SERVICE BULLETIN

* Supersedes Service Bulletin SB900-069, dated 01 June 1999. Reason For Revision: Administrative documentation change for clarification; to delete an unused part from the Replacement Parts list, clarify interconnect diagram, and add the requirement for the prior incorporation of Service bulletin SB900-063. This revision does not affect the installation of this modification and aircraft which have complied with SB900-069 meet the intent of this revision.

A612 FORWARD INTERCONNECT PANEL MODIFICATION

Forward Interconnect Panel PN: 900E2750612-ALL.

Figure 1. Modification Wiring Diagram

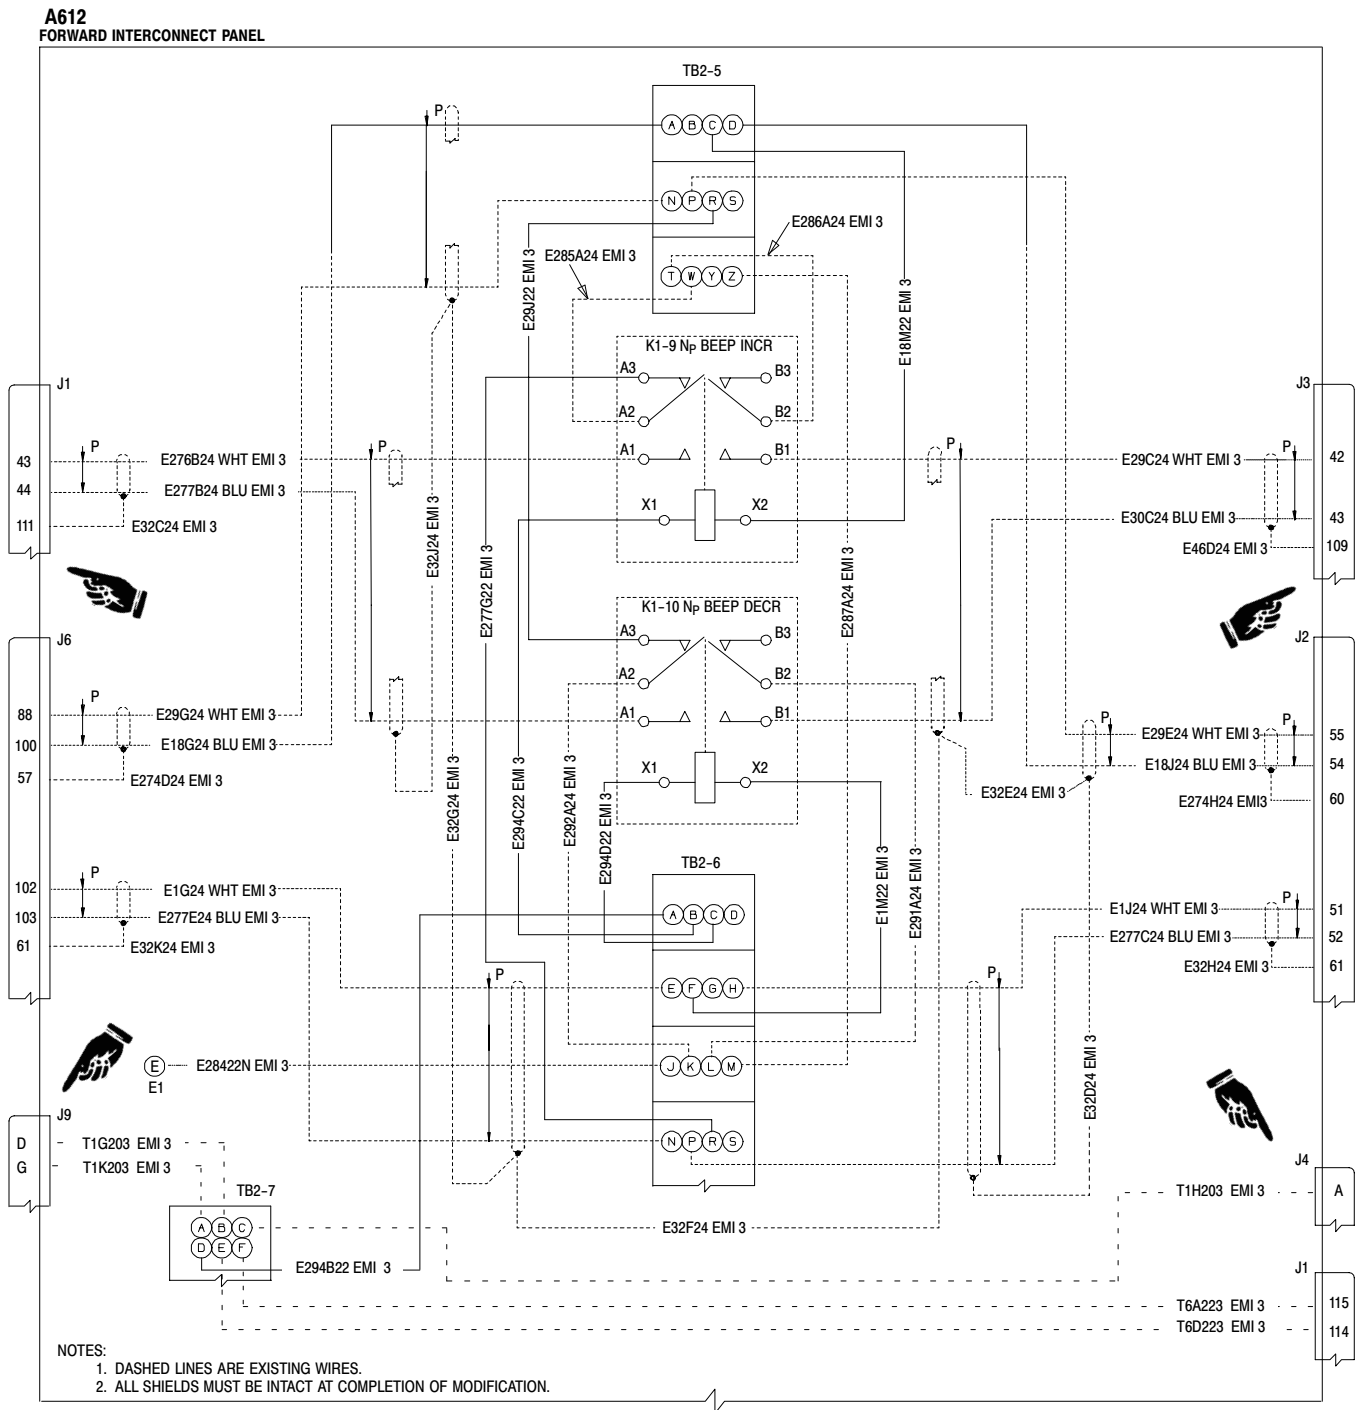
Wiring in the collective stick(s) wire harness is protected by a circuit breaker that is too large for the wire size. Not complying with this Bulletin in conjunction with a short circuit condition may result in a fire or unpredictable operation of any collective head control functions.

This Bulletin provides the owner/operator with information to modify the Forward Interconnect Panel. This modification re-configures the electrical circuit to use the wires installed in the collective sticks as the ground path instead of the power path.

- (8). Remove wire E98B24 EMI 3 from TB2-5D and J2-8 and discard.
- (9). Remove wire E294A24 EMI 3 from TB2-6A and TB2-7D and discard.
- (10). Remove wire E94F24 EMI 3 from TB2-5A and J6-12 and discard.

- (11). Install wire E29J22 EMI 3 from TB2-5R to K10-A3.
- (12). Install wire E294D22 EMI 3 from TB2-6C to K10-X1.
- (13). Install wire E18M22 EMI 3 from TB2-5C to K9-X2.

- (14). Install wire E1M22 EMI 3 from TB2-6F to K10-X2.
- (15). Install wire E277G22 EMI 3 from TB2-6R to K9-A3.
- (16). Install wire E294B22 EMI 3 from TB2-6A to TB2-7D.

- (17). Install wire E294C22 EMI 3 from TB2-6B to K9-X1.
- (18). Remove wire E18G24 BLU EMI 3 from TB2-6C and install in TB2-5A. Splice wire if necessary (Ref. CSP-900RMM-3).

- (19). Remove wire E18J24 BLU EMI 3 from TB2-6D and install in TB2-5D. Splice wire if necessary (Ref. CSP-900RMM-3).
- (20). Tie new wires into existing wire harness.
